UIUC Technical Specifications

Changes with Revision Marks

10/1/99

Changes To Be Inserted

CHART I: Administrative organization of the reactor facility. Dashed lines indicate reporting paths outside the operational chain of supervision, indicated by solid lines.

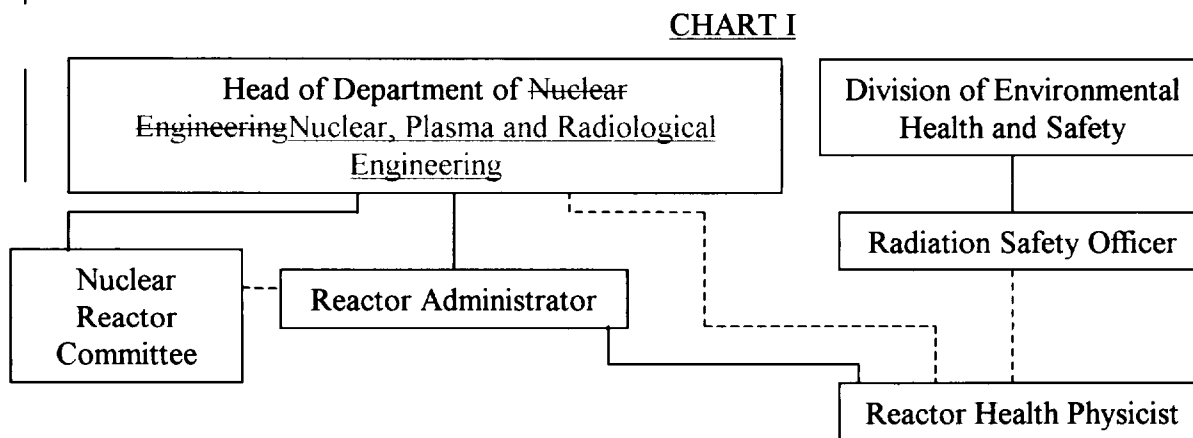
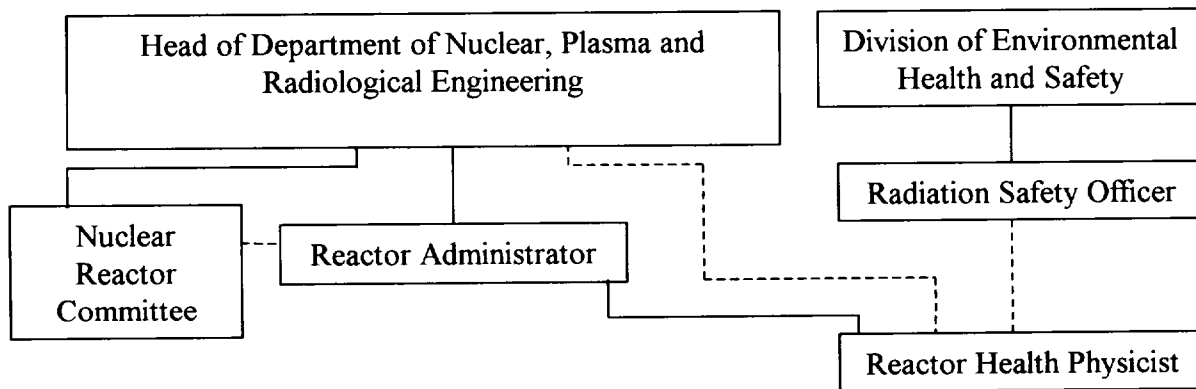
- a. The reactor facility shall be an integral part of the Department of ~~Nuclear Engineering~~ Nuclear, Plasma and Radiological Engineering of the University of Illinois. The reactor shall be related to the University structure as shown in Chart I.

- a. The reactor facility shall be an integral part of the Department of Nuclear, Plasma and Radiological Engineering of the University of Illinois. The reactor shall be related to the University structure as shown in Chart I.
